# REGIONAL REVIEW FINDING

ARC REVIEW CODE: R14052101

**Name of Proposal:** Braves Stadium and Mixed Use Development

**SUBJECT:** **Transportation Division Review of DRI # 2381**  
Project: Atlanta Braves Stadium and Mixed-Use Development  
County: Cobb  
Location: Block bordered by Circle 75 Pkwy to the South and East, Windy Ridge Pkwy to the North, and Cobb Pkwy/US 41 to the West  
Analysis:  
Expedited ☐  
Non-Expedited ☒

**Figure 1: Pedestrian Connection between “South Parking” and Braves Development Site**

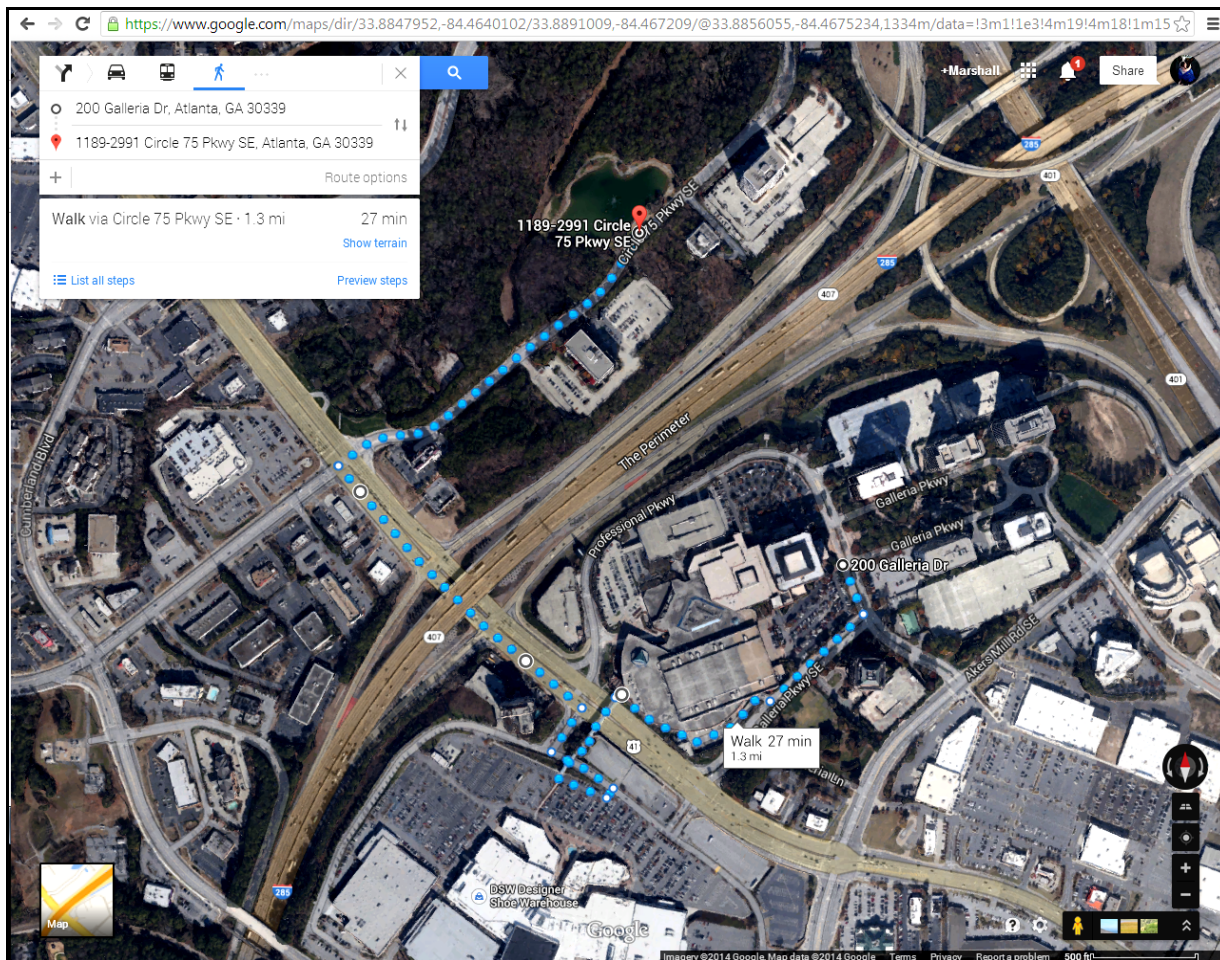
Approximately 35% of vehicles will park in the “South Parking” area (see Figure 7 in the Transportation Analysis submitted by Kimley-Horn & Associates). The pedestrian connection from that area’s midpoint to the Braves stadium is a 1.3 mile walk (27 minutes). There is no sidewalk on the northbound side of Cobb Parkway between the Cobb Galleria complex and the I-285 West exit ramp at Cobb Pkwy, thus requiring pedestrians to cross Cobb Pkwy via the Cobb Galleria/Cumberland Mall pedestrian bridge and then cross again at Circle 75 Pkwy which currently has 11 lanes of travel (the submitted site plan recommends additional lanes). Access from the south of the subject site was not included in the *Bicycle and Pedestrian Facilities* (Section 1.4) of the Transportation Analysis.

- One example is there are no sidewalks on NB side of Cobb Pkwy at I-285. The lack of sidewalks forces those who park in "South Parking" to cross Cobb Pkwy at Cumberland Mall via pedestrian bridge, then cross 11 lanes at Circle 75 Pkwy (the submitted site plan shows 15 lanes). The sidewalk on the SB side of Cobb Parkway may need to be widened to accommodate the large number of pedestrians that will utilize this facility in accessing the site. Cobb Pkwy in this area has an annual average daily traffic of 42,070 (2012 GDOT STARS data).

The County and the developer should work to provide pedestrian facilities on both sides of all potential pedestrian routes that are ADA compliant and wide enough to handle the expected number of users. The County and the developer should investigate other pedestrian comfort and safety measures such as improved lighting, pedestrian-roadway buffer, improved crossings and even the use of off-duty police officers at appropriate intersections. In addition to pedestrian facilities, bicycle facilities should be provided as well both on street, at parking facilities and at the development site itself.

**Figure 2: Pedestrian Connection from Cumberland Transfer Center to Braves Development Site**

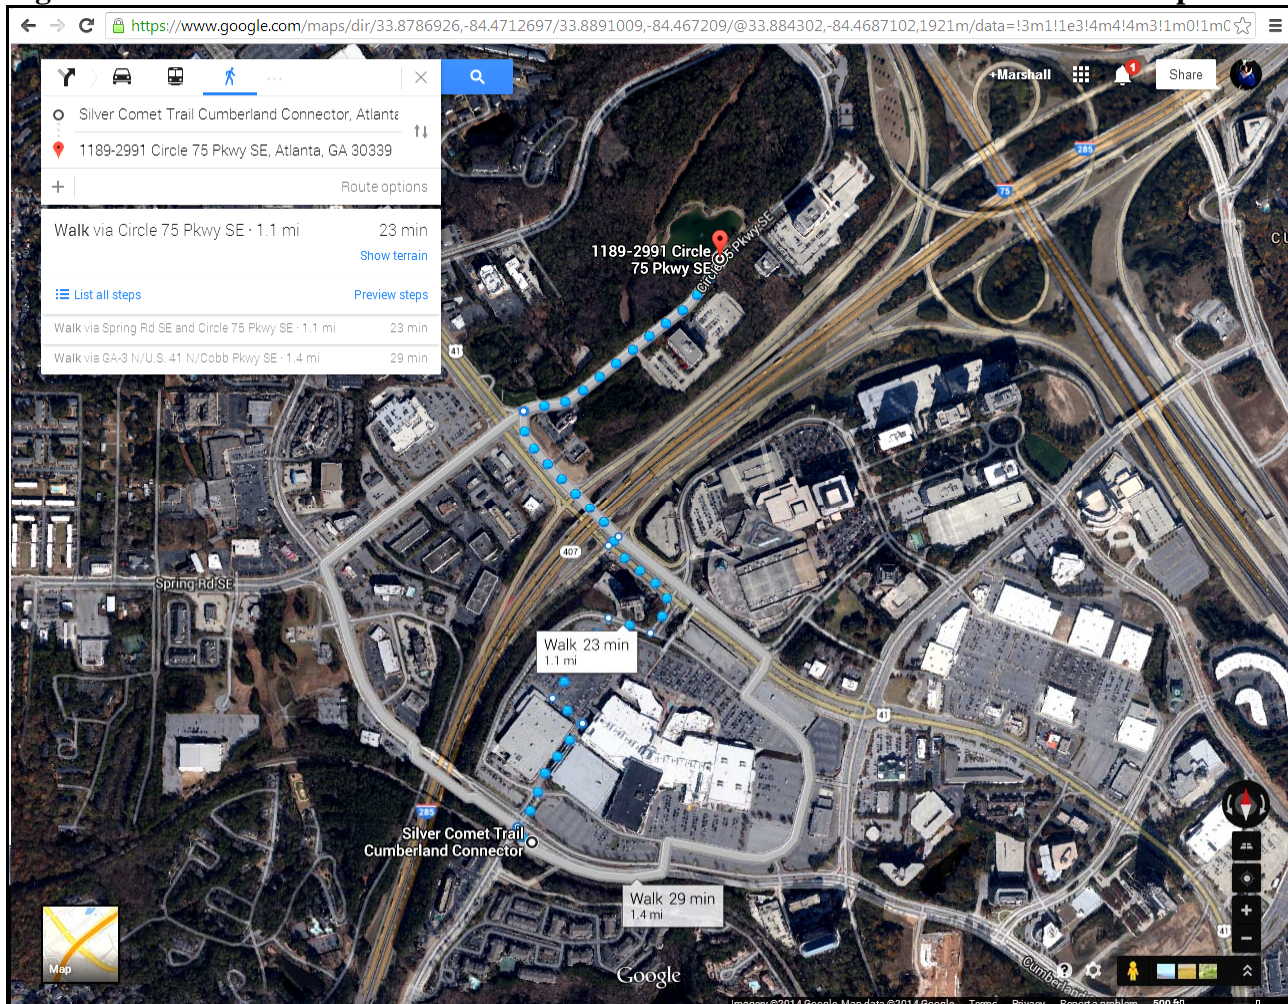
The site is directly served by Cobb Community Transit. The Cumberland Transfer Center is located on the south side of Cumberland Mall and is served by MARTA Bus Route 12 (between Midtown, Atlanta and the Cumberland Transfer Center), and Cobb Community Transit Bus Routes 10, 10A, 10B, 20, and 50. The Cumberland Transfer Center is an approximate 1.1 mile, 23-29 minute walk to the subject site (Figure 2).

Int# 32    New Northside Drive & Northside Drive  
PM Pk Hr   5:00 – 6:00

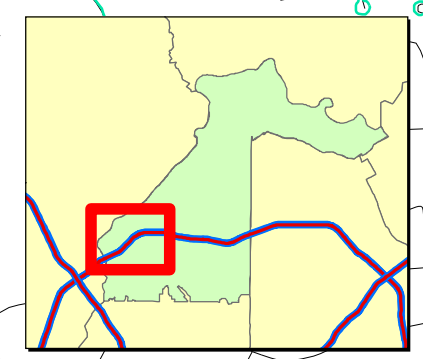
In the 2019 Build Condition, the results of the KHA analysis show that intersection #32 is failing. The attached matrix (Int32\_HCM) provides a summary of the KHA Synchro 8 analysis of the intersection through the four network evaluation periods (Existing 2014, No-build 2019, Build 2019, Build 2019 improved). Since the Build 2019 network shows a failing LOS for the westbound through movement, the resulting westbound approach and intersection LOS is also F. The improvement proposed by KHA to address the failing LOS is as follows: "Restripe Northside Drive to allow a free-flow eastbound right-turn. Install southbound and westbound right-turn overlaps." Staff concerns about the proposed modification are as follows:

In reviewing the Synchro analysis, Public Works staff observes that a modification to the signal timing may improve the intersection LOS in lieu of the proposed geometric modification. For example, it appears that by providing more green time to the westbound thru movement and increasing the cycle length can reduce the intersection LOS to E or better. This may be a potential alternative option to the proposed free-flow right-lane conversion.
